Woodstock Village BF 020-2(43) contractor fabricated approach slabs resubmit 1/26/18.pdf

RESUBMIT No Approved
 BY Rob Young DATE 02-06-2018

COLD RIVER BRIDGES, LLC	
10 LANBRO LANE	
TEL 603-756-9800	WALPOLE, NH FAX 603-756-9803
WOODSTOCK BF 020-2(43)	
DETAILS/TYP SECT	SHEET NUMBER
REVISION #1 1/26/18	3
DATE 2/20/17

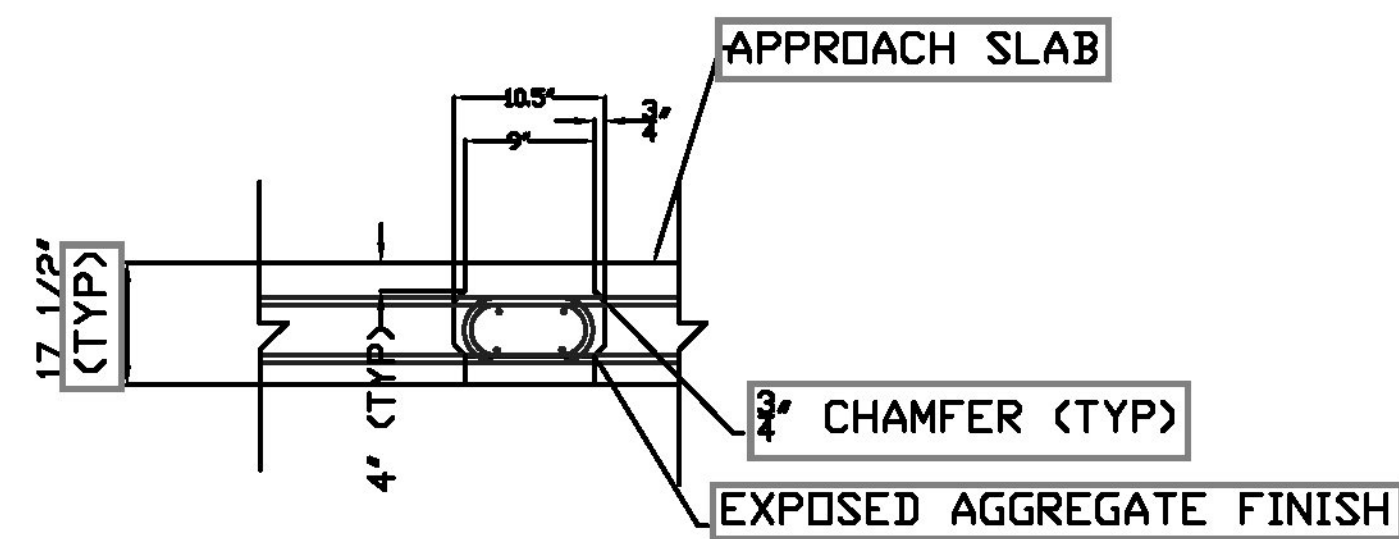
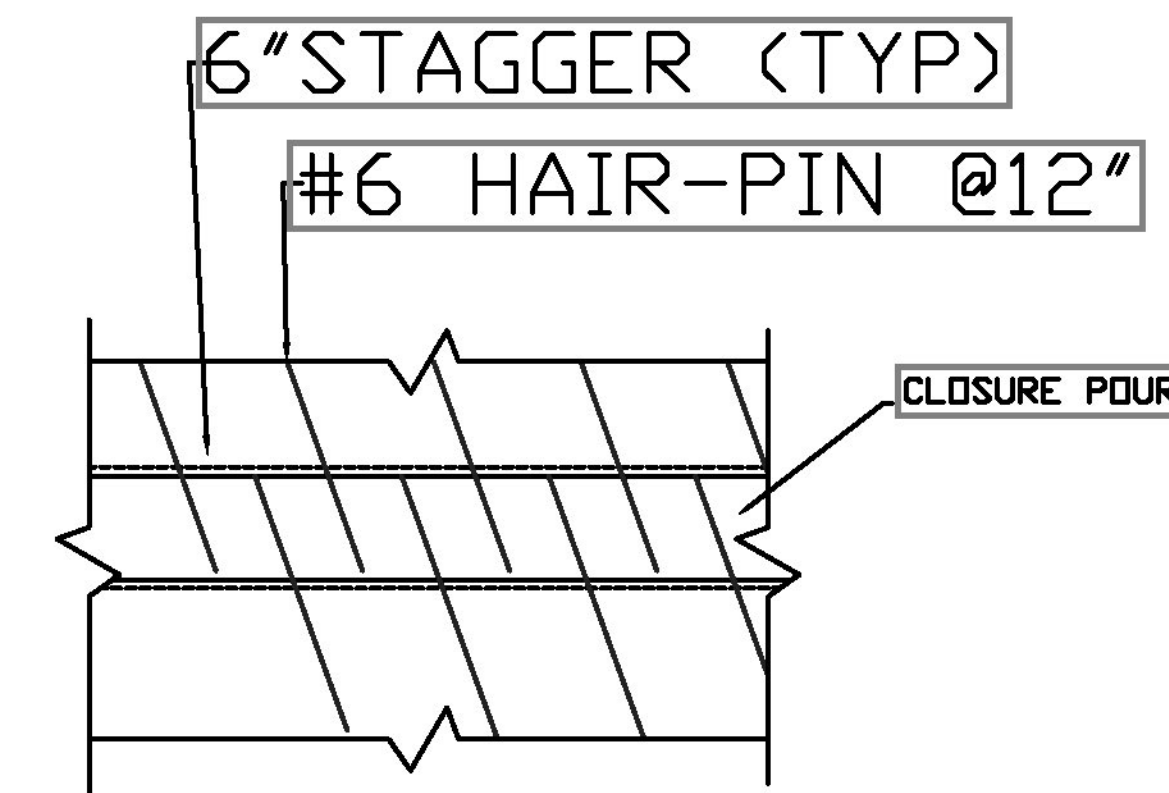
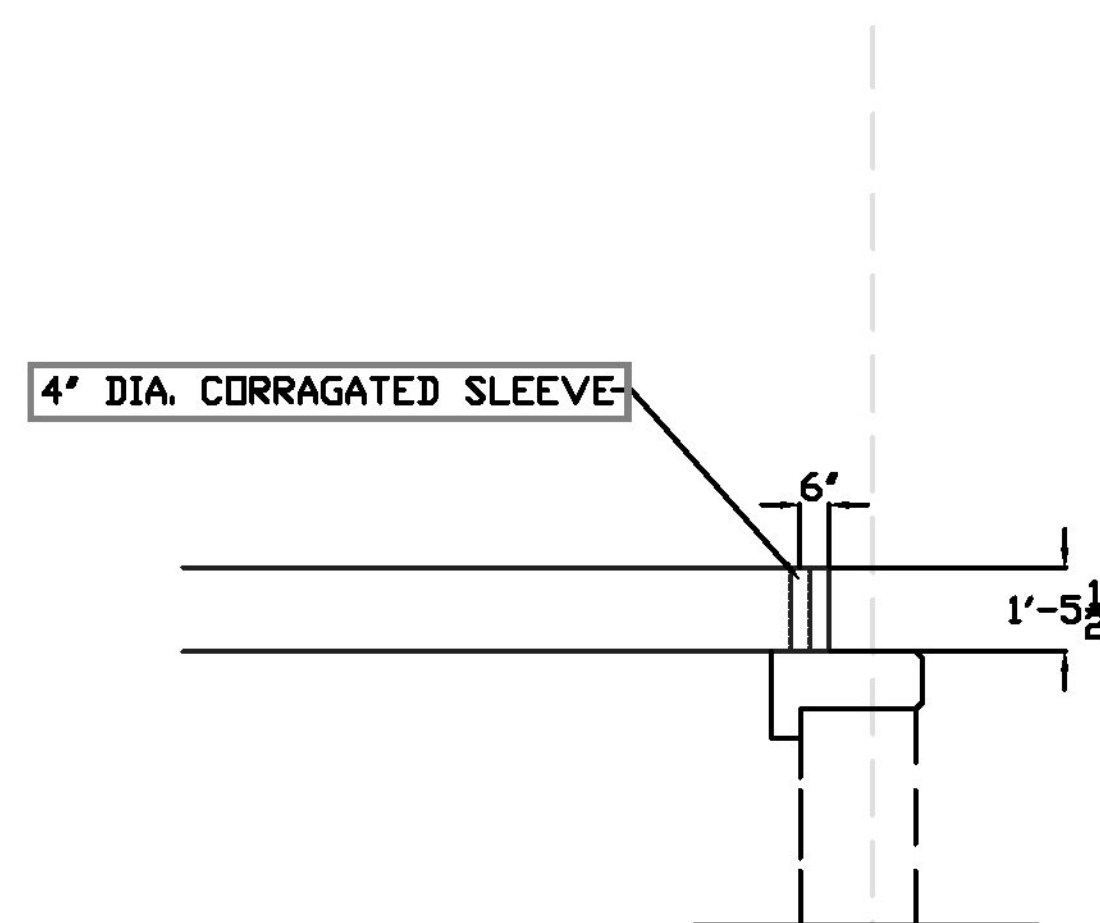
***** SPECIAL ATTENTIONS:**
 APPROACH SLAB KEY-WAY REINFORCING BETWEEN ADJACENT SECTIONS (#6 HAIR-PINS) MUST BE OFF-SET 1/2 BAR SPACING TO ALLOW FOR PROPER ALIGNMENT
